**Re: Schedule 5 dated 10/03/2016**  
**Permit Reference Number: EPR/GB3490HG/A001**  
**Facility: Nine Mile Point Waste Processing Facility**  
**Operator: Hazrem Environmental Limited**

**Table 1: Responses to Schedule 5 Request for Information**

**Figure 1: Met Office Weather Data**

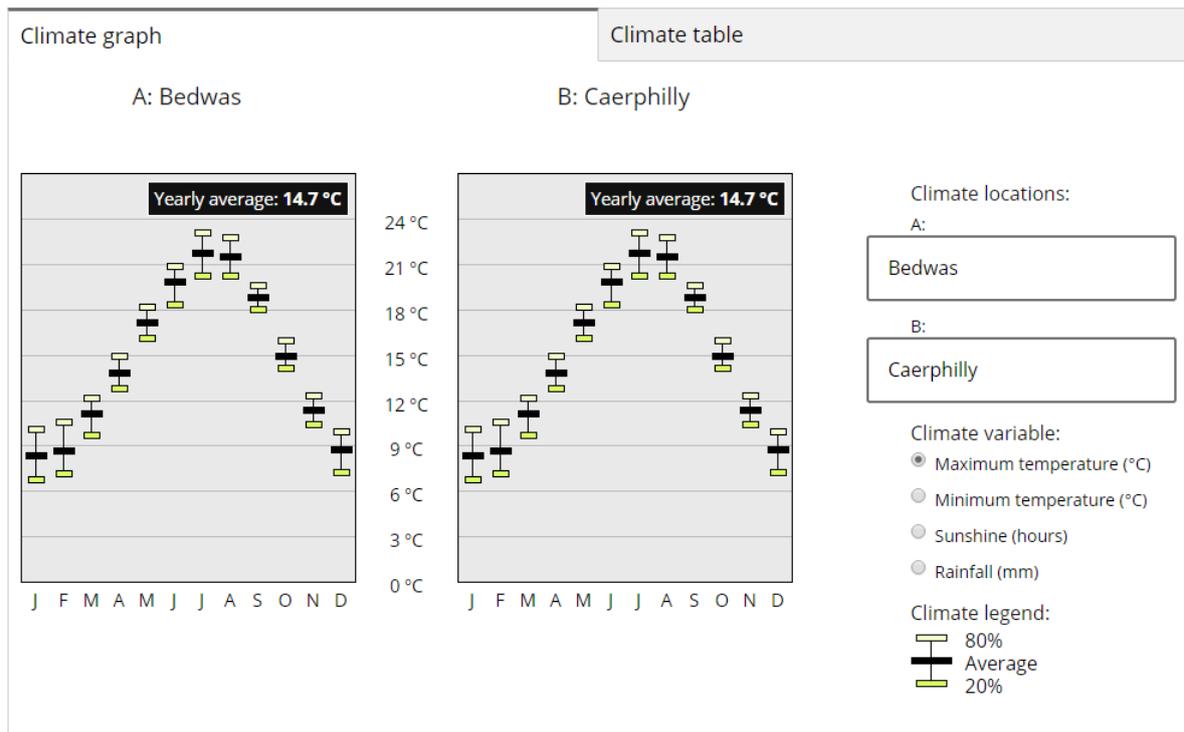
7	Table 1 – odour from failure of the plant. <b>Please clarify what procedures will be in place in the event of plant failure</b>	<p>In the case of failure of the plant the doors will remain closed. The cause of the failure will be investigated and rectified. If there is a risk of odour from the plant waste will not be accepted until the plant failure have been rectified.</p> <p>Critical spares parts will be held onsite and staff will be trained in appropriate maintenance procedures to ensure that plant failures are rectified in a timely manner.</p>
8	Appendix B, Caerphilly weather station information. The average air temperature looks high. <b>Please verify the representativeness of the Caerphilly weather station information.</b>	<p>Upon review of Met Office data, Bedwas is the closest weather station however results are virtually identical to Caerphilly (see comparison in Figure 1 below).</p> <p>It is considered that either weather station provides appropriate temperature levels for the area surrounding Nine Mile Point Industrial Estate.</p> <p>The average air temperature at the Bedwas weather station is 14.7°C which is the same as the average temperature at Caerphilly weather station. When comparing this information to the average temperature data given for the Caerphilly Weather Station on windfinder.com, 13 °C the average temperature given on windfinder.com is actually slightly less, than that provided by the Met Office data. This difference may be due to the fact that the Met Office data is only available up to 2010.</p>
